Product Change Notification / CENO-16DNCZ633

CCB 5332 Initial Notice: Qualification of palladium coated copper with gold flash (CuPdAu) bond wire material and 104x150 mils lead-frame paddle size for selected PIC16F153xx, PIC16F183xx, PIC16F184xx, PIC16LF15xx and PIC16LF18xx device families available in 14L SOIC (.150in) package.

CCB No.: 5332

Pre Change

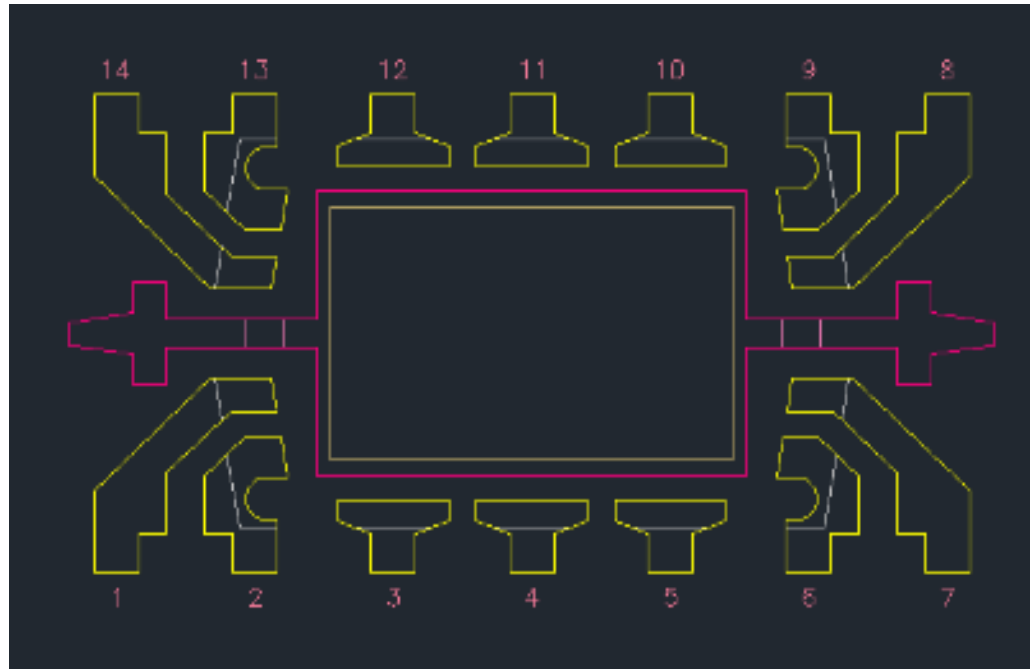
Lead Frame Material	A194
Paddle size	95 x 155 mils
DAP Surface Prep	Ag
Wire Material	Au

Post Change

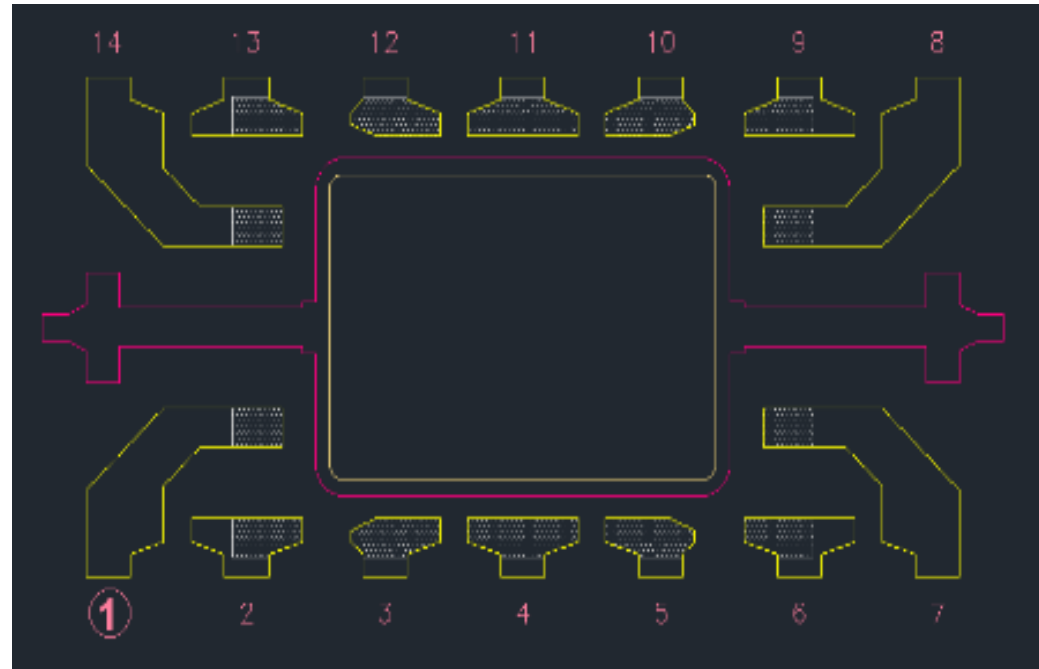
Lead Frame Material	A194
Paddle size	104 x 150 mils
DAP Surface Prep	Bare Cu
Wire Material	CuPdAu
